NWCAA ENFORCEMENT REPORT

NOV: 4074 **Dates of Violation:** 9/4/12-9/5/13 **Report Date:** 3/11/14

Sources: Tesoro Refining & Marketing Company LLC (9/4/12-9/5/13)
 Tesoro Logistics Operations LLC (11/15/12-9/5/13)
 7969 North Texas Road
 Anacortes, WA 98221

1 - Photo of disconnected sump pump effluent line

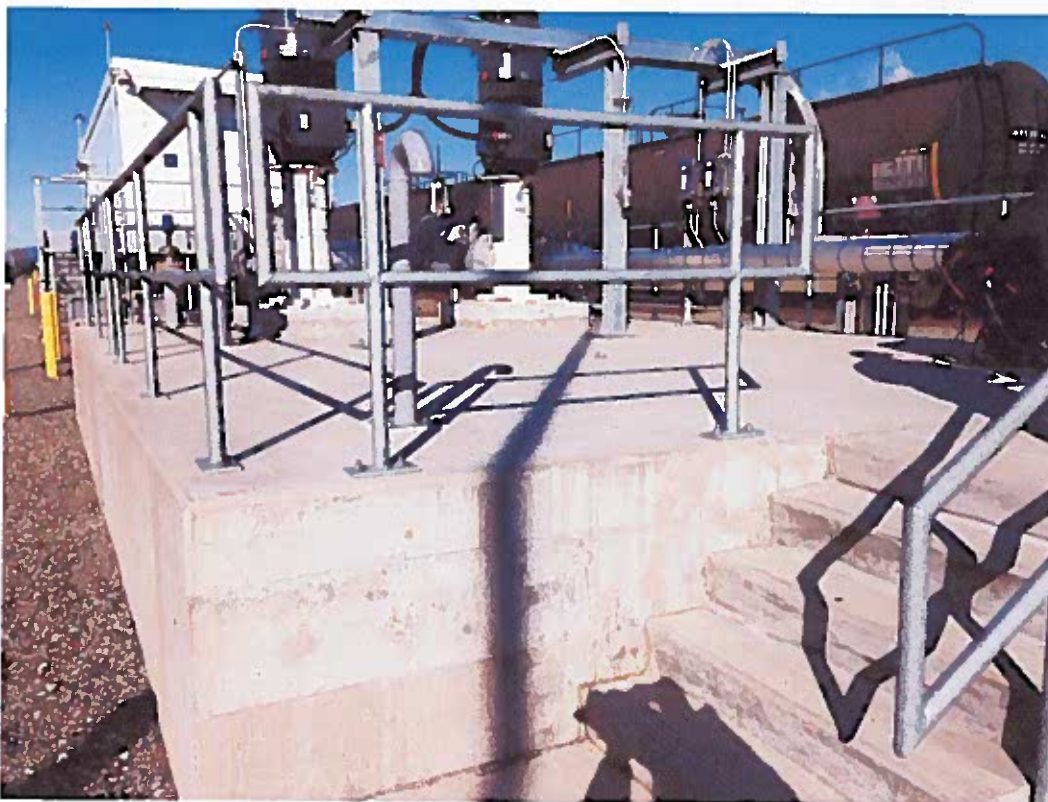
The pump vault sump line was observed excavated on the east side of the vault (Photo 1). The rerouting of the line to the crude header was confirmed. The original line that routed the pump vault sump discharge to the wastewater junction box was not removed, but lies disconnected at the excavation point.
